PARTIAL LEVEL-09 FRAMING PLAN (PHASE-8) (SEQ#47)

SK#23
17 pages
35 Queries
Date: 07-14-2025

PROJECT DESCRIPTION : 1250 MARYLAND AVENUE

1 PARTIAL PENTHOUSE ROOF FRAMING PLAN (PHASE-8) (SEQ#50)

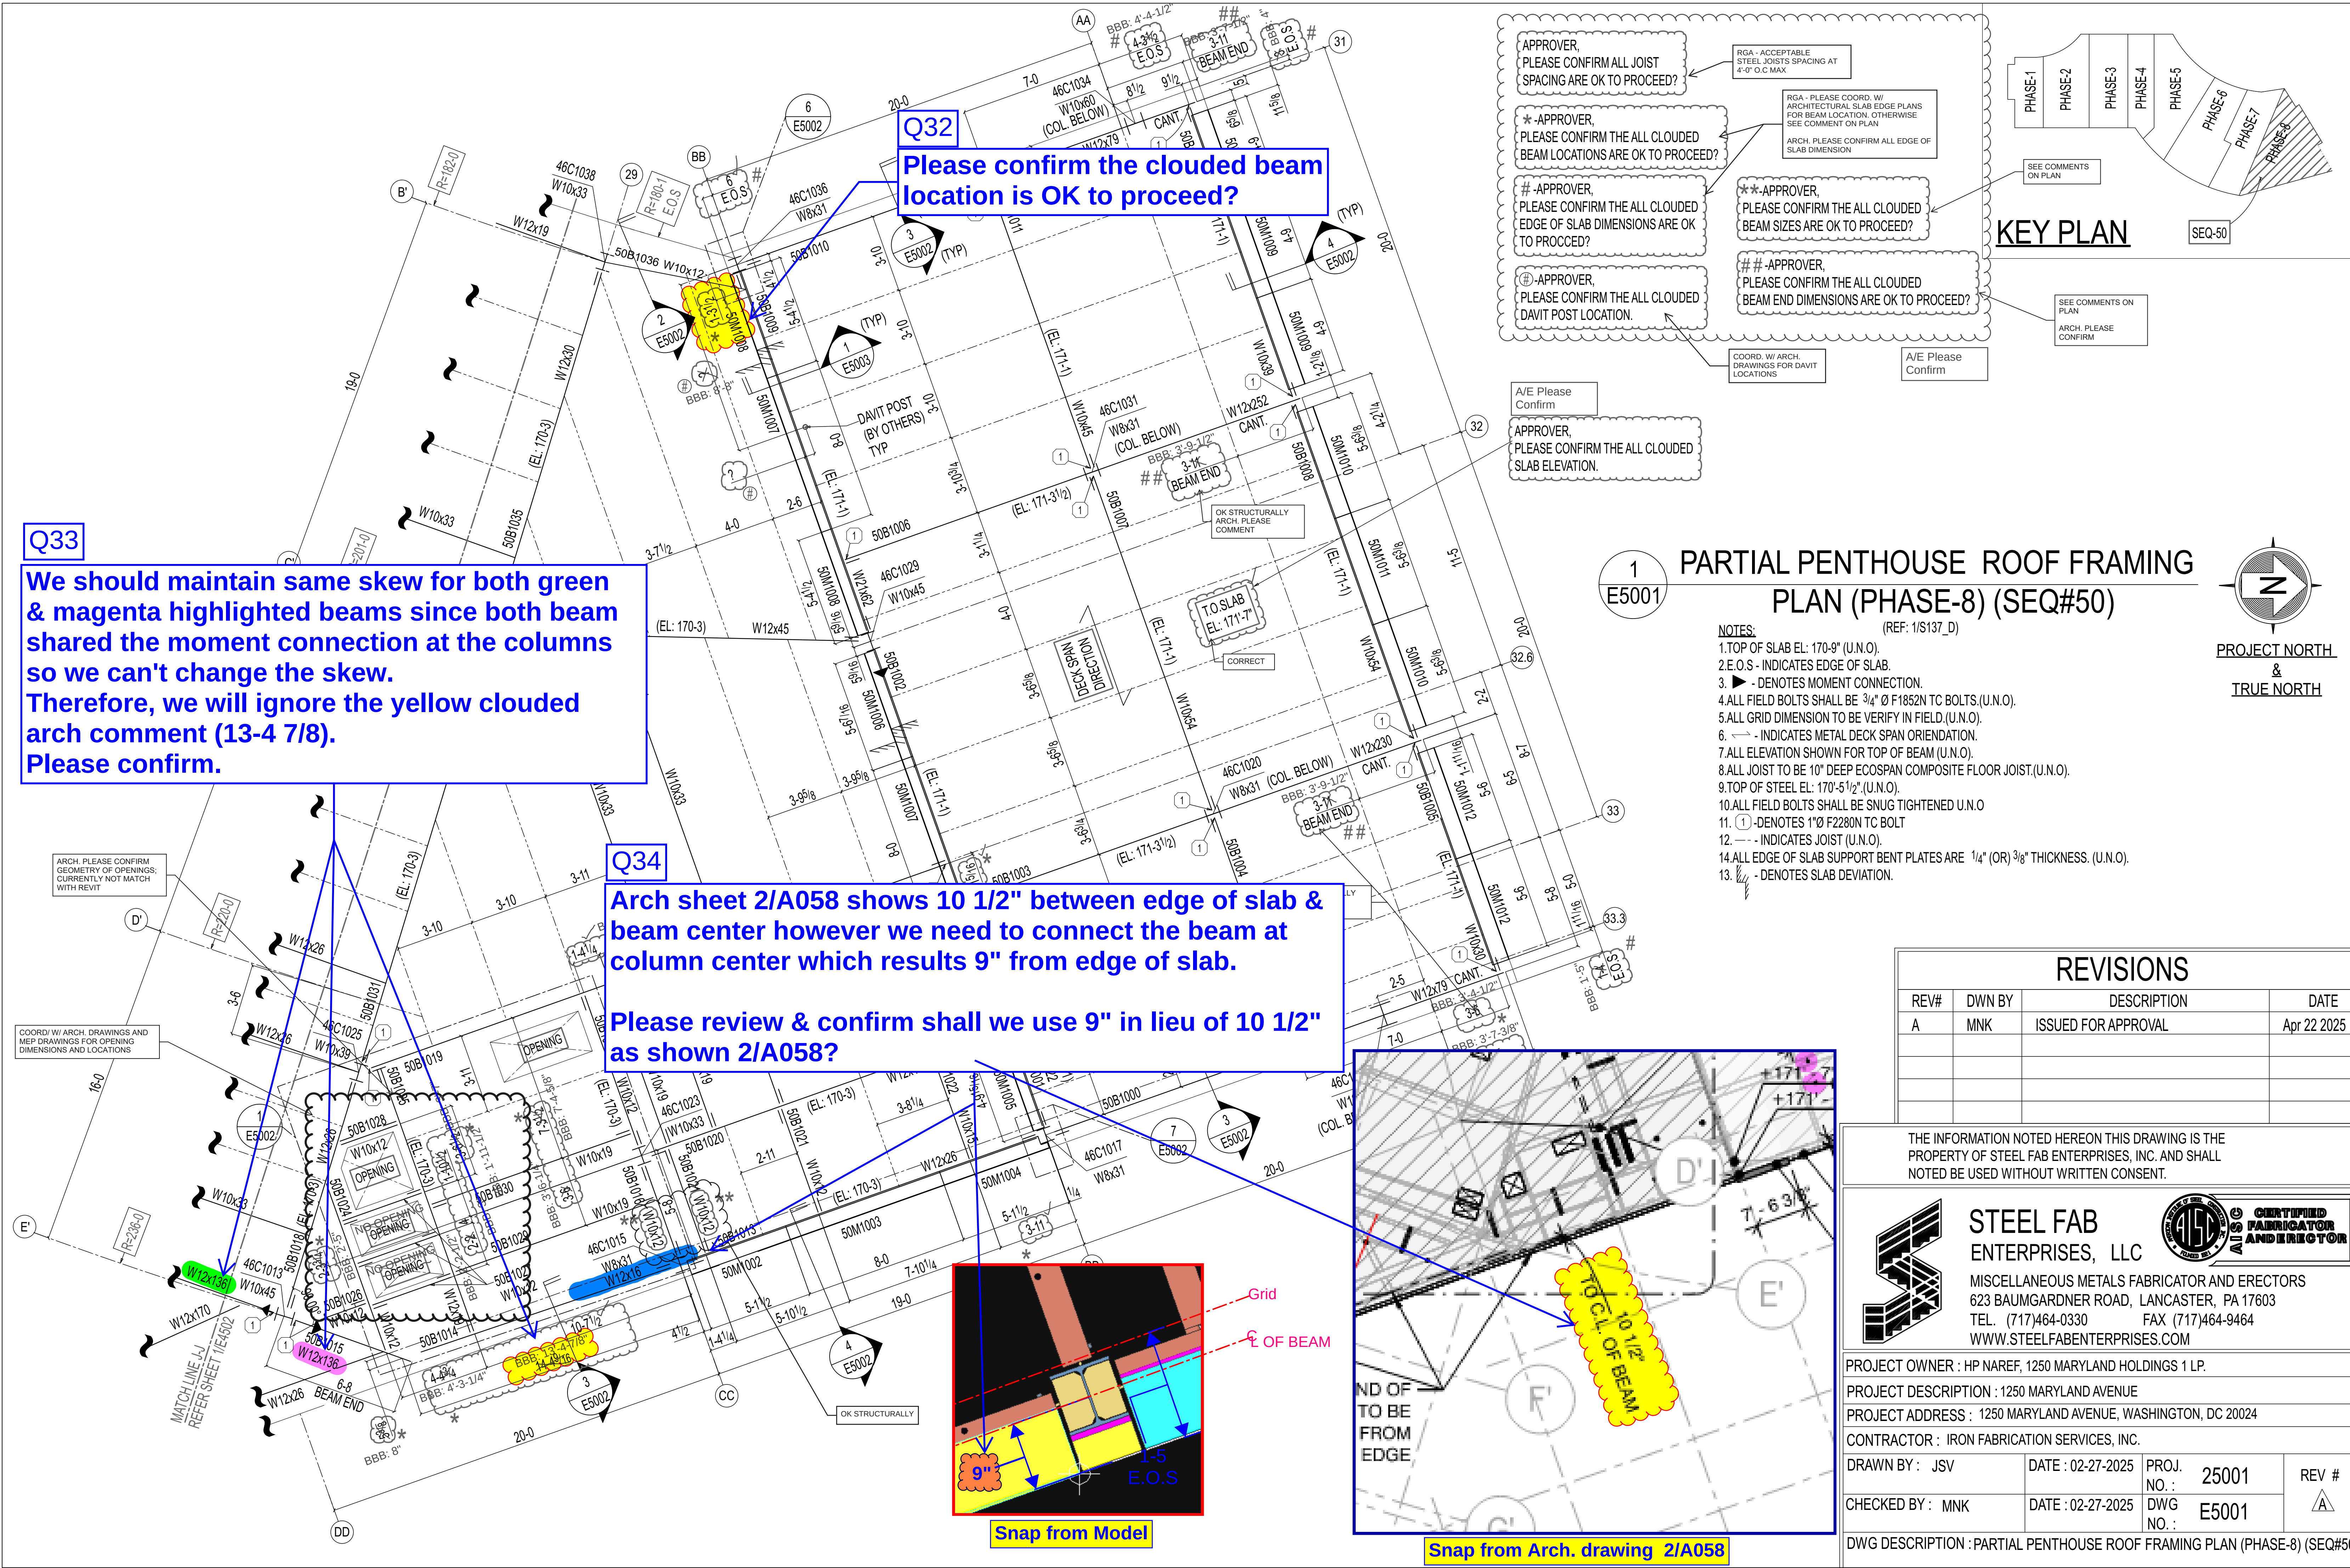
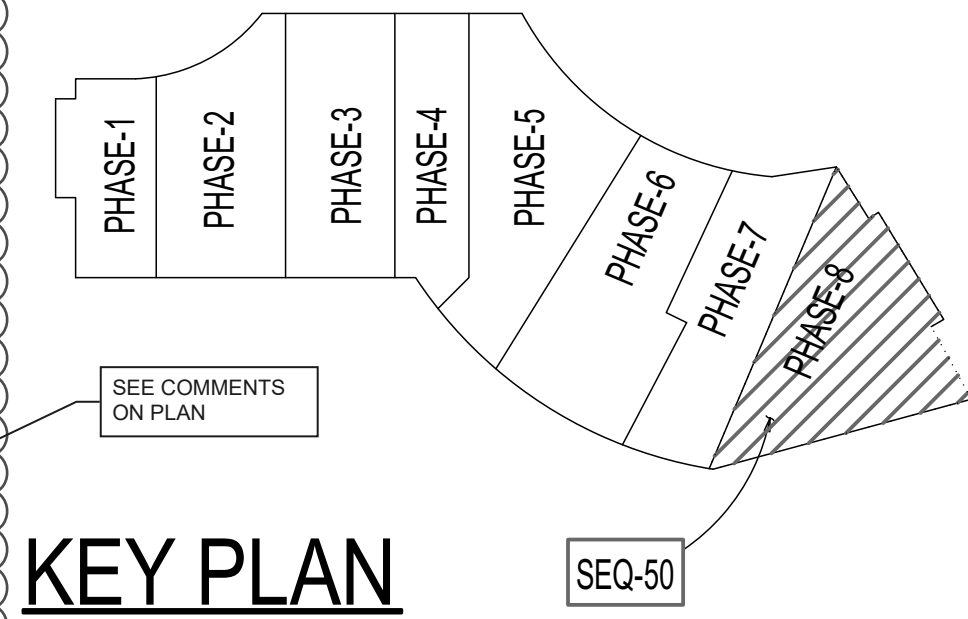
We should maintain same skew for both green & magenta highlighted beams since both beam shared the moment connection at the columns so we can't change the skew. Therefore, we will ignore the yellow clouded arch comment (13-4 7/8). Please confirm.

Arch sheet 2/A058 shows 10 1/2" between edge of slab & beam center however we need to connect the beam at column center which results 9" from edge of slab.

Please review & confirm shall we use 9" in lieu of 10 1/2" as shown 2/A058?

Please confirm the clouded beam location is OK to proceed?

APPROVER, PLEASE CONFIRM ALL JOIST SPACING ARE OK TO PROCEED?

*-APPROVER, PLEASE CONFIRM THE ALL CLOUDED BEAM LOCATIONS ARE OK TO PROCEED?

#-APPROVER, PLEASE CONFIRM THE ALL CLOUDED EDGE OF SLAB DIMENSIONS ARE OK TO PROCEED?

Ⓜ-APPROVER, PLEASE CONFIRM THE ALL CLOUDED DAVIT POST LOCATION.

APPROVER, PLEASE CONFIRM THE ALL CLOUDED SLAB ELEVATION.

**APPROVER, PLEASE CONFIRM THE ALL CLOUDED BEAM SIZES ARE OK TO PROCEED?

##-APPROVER, PLEASE CONFIRM THE ALL CLOUDED BEAM END DIMENSIONS ARE OK TO PROCEED?

RG- ACCEPTABLE STEEL JOISTS SPACING AT 4'-0" O.C MAX

RG- PLEASE COORD. W/ ARCHITECTURAL SLAB EDGE PLANS FOR BEAM LOCATION, OTHERWISE SEE COMMENT ON PLAN

1
E5002
DETAIL
OTHERS NOT SHOWN FOR CLARITY

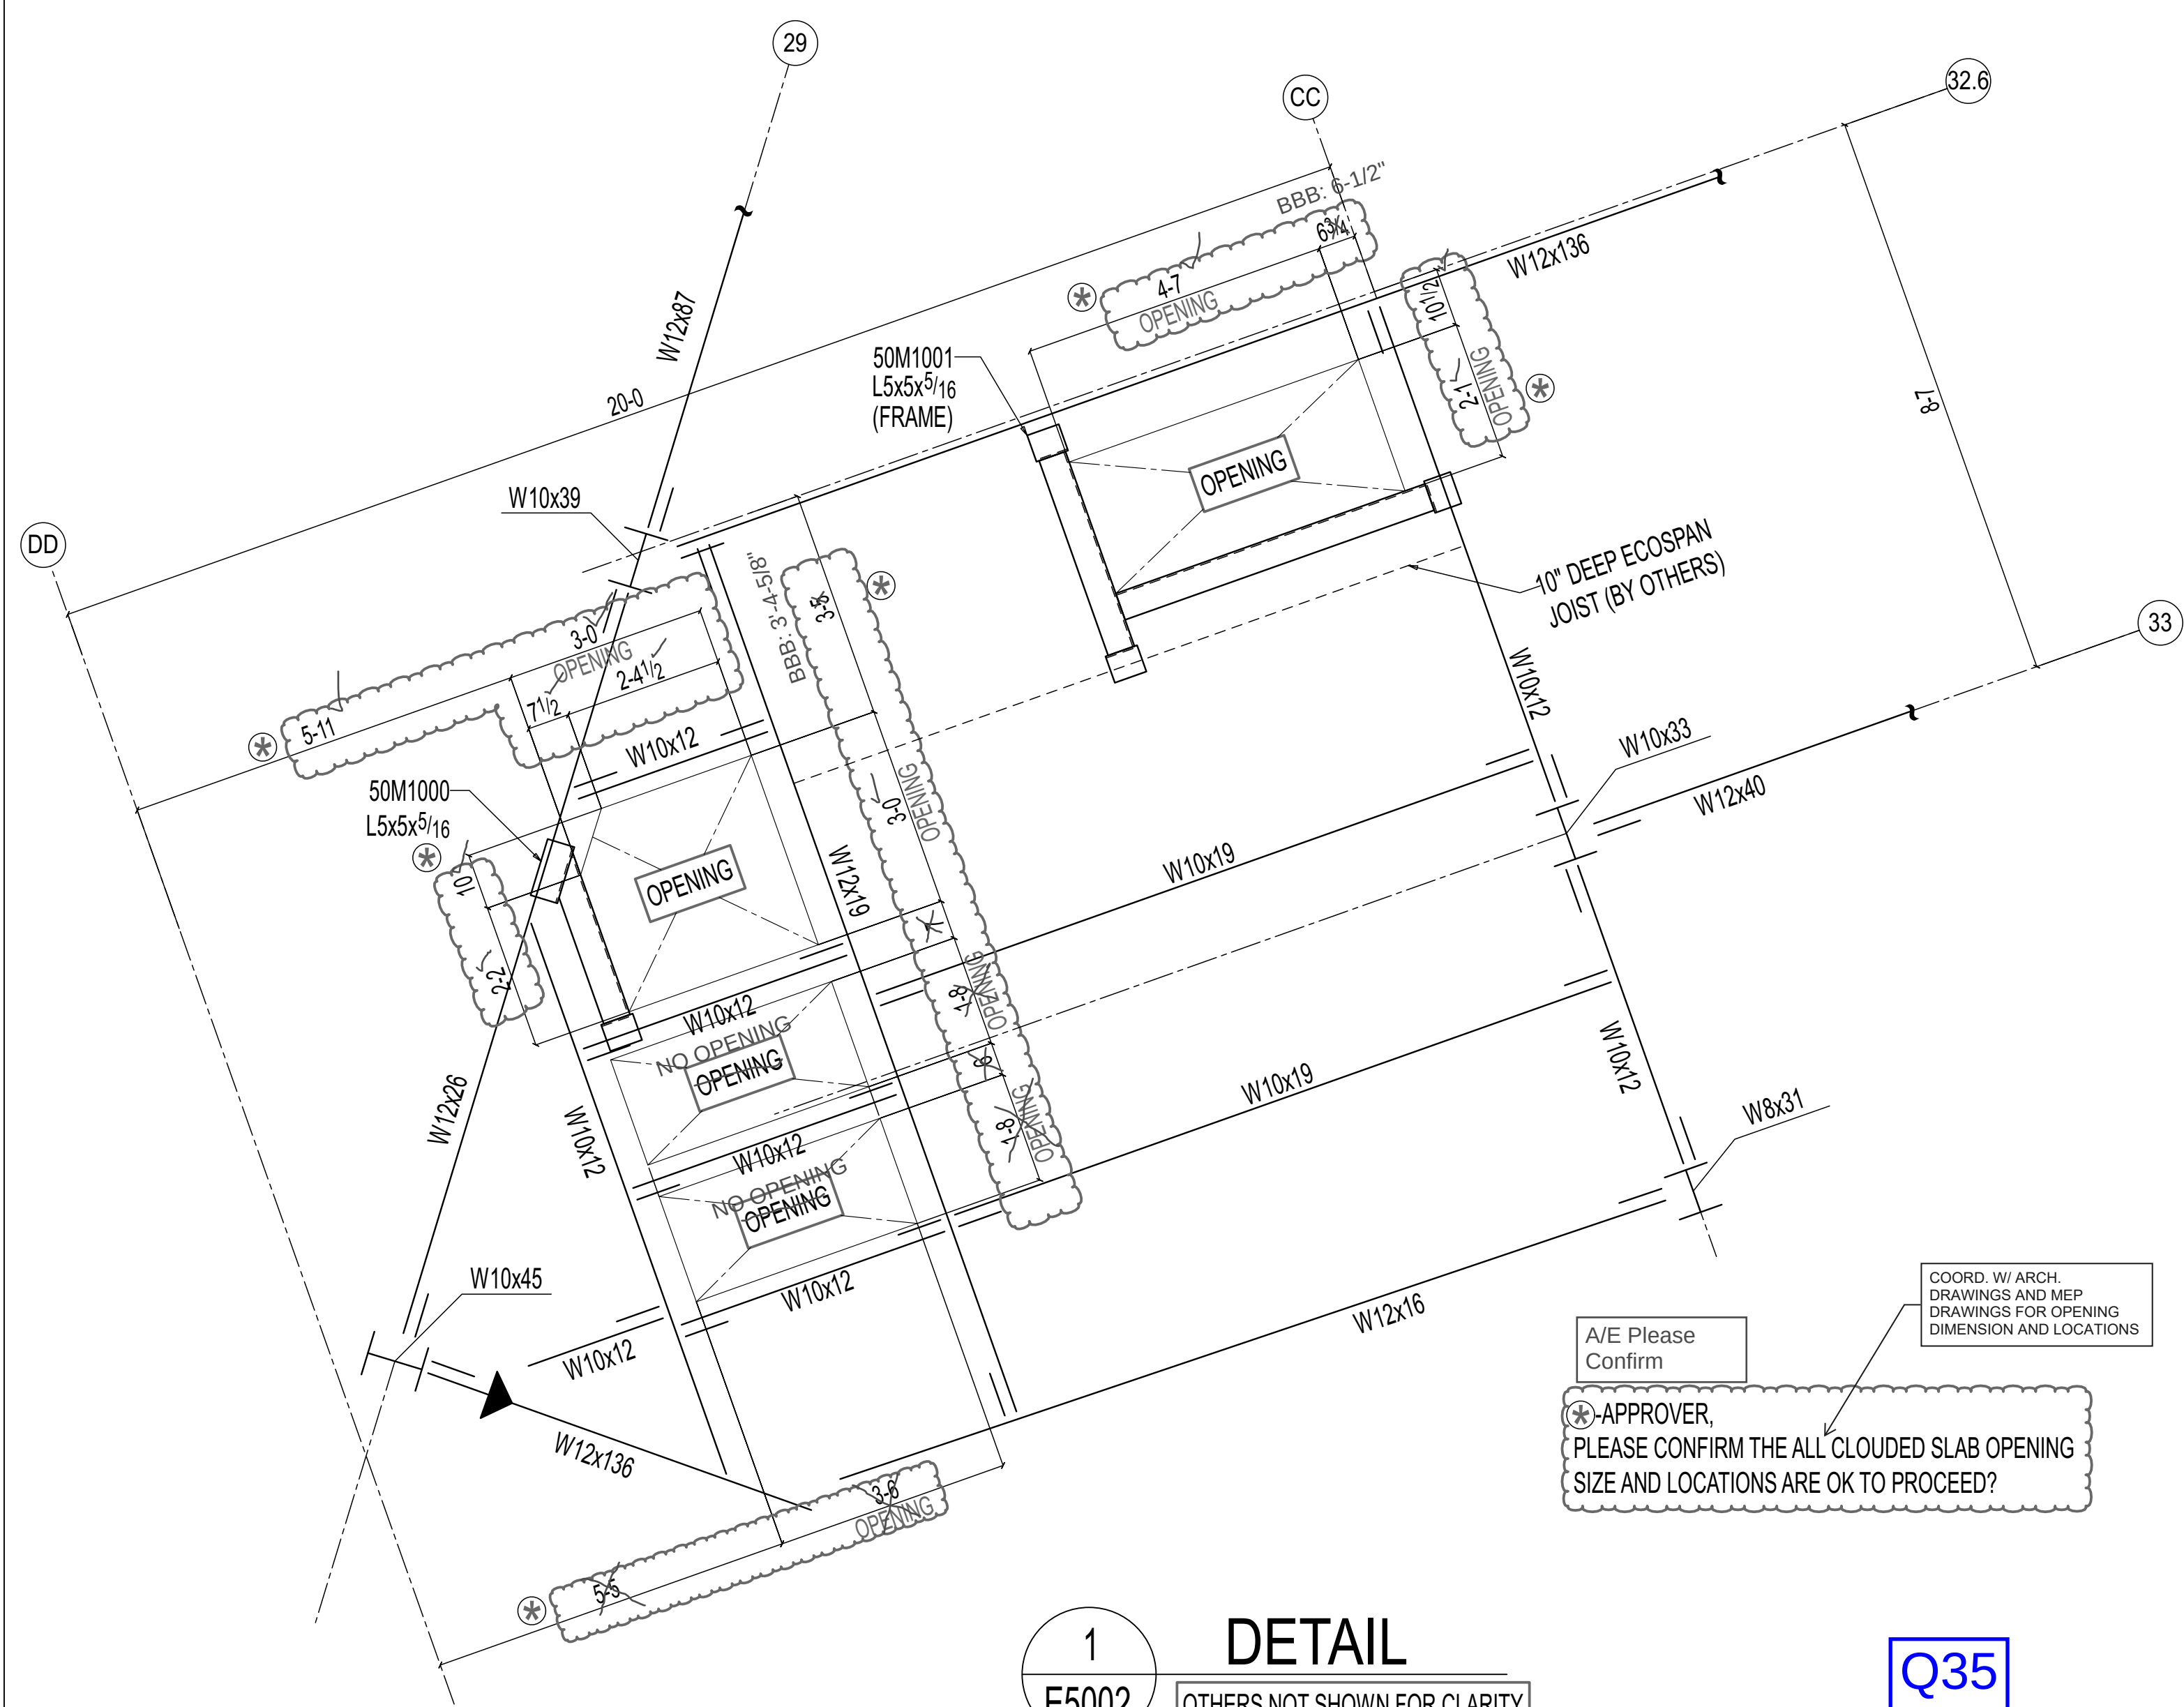
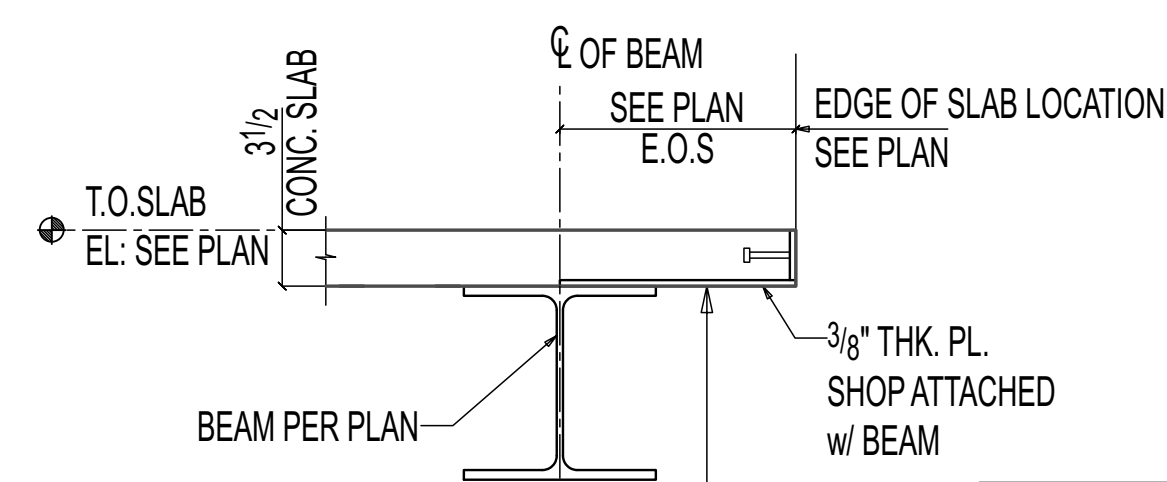
**Arch,
Please confirm the clouded
edge of slab dimension is OK to
proceed?**
